WEST WINDSOR TOWNSHIP

MEMORANDUM

SUBJECT: **ER/UDC West Windsor, LLC**
Preliminary and Final Major Subdivision Phases 1 & 2
Preliminary and Final Major Site Plan Phase 1
Preliminary Major Site Plan Phase 2
Block 47, Lots 2, 3, 4, 5 & 6
Princeton-Hightstown Road (CR 571), Southfield Road & McGetrick Lane
PB 22-02

Figure 1: Recommended Layout of McGetrick Lane

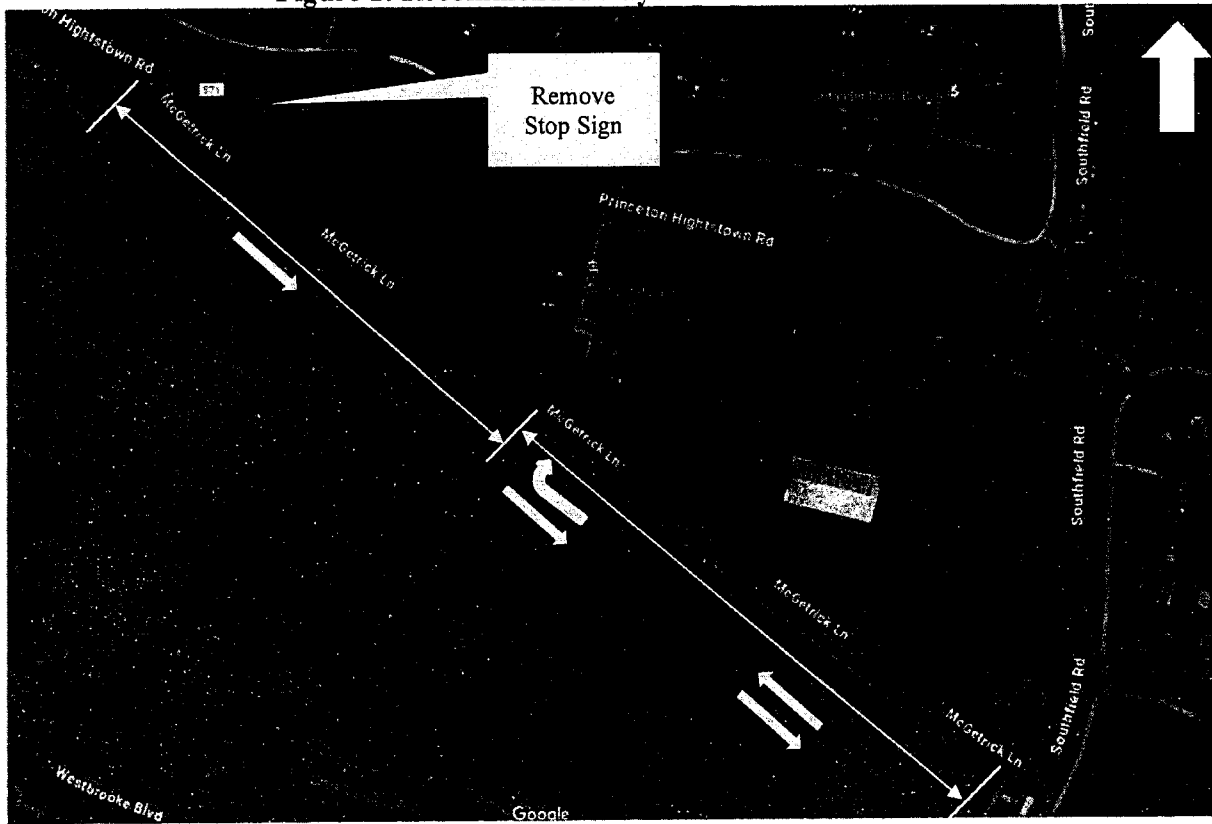
- This memo recommends that the Planning Board and/or the Township Council to revise/amend Township Code Section §168-57 to redesignate McGetrick Lane roadway section to be converted to one-lane-one-way eastbound (from existing two-way configuration) between Princeton-Hightstown Road (C.R. 571) and the Tuttle Dental office driveway. East of the Tuttle Dental office driveway, McGetrick Lane will operate as a two-lane-two-way roadway. The roadway directional layout is shown graphically below.
- Additionally, this memo recommends the West Windsor Township to take appropriate measures to remove the existing Stop sign posted at the corner of McGetrick Lane and CR 571 intersection.

The proposed directional configuration along McGetrick Lane and the recommended removal of the Stop sign are shown below in **Figure 1** through **Figure 4**; where **Figure 3** and **Figure 4** represents the Site Plans received above from both Bohler Engineering NJ, LLC and Atlantic Traffic and Design Engineering, LLC.
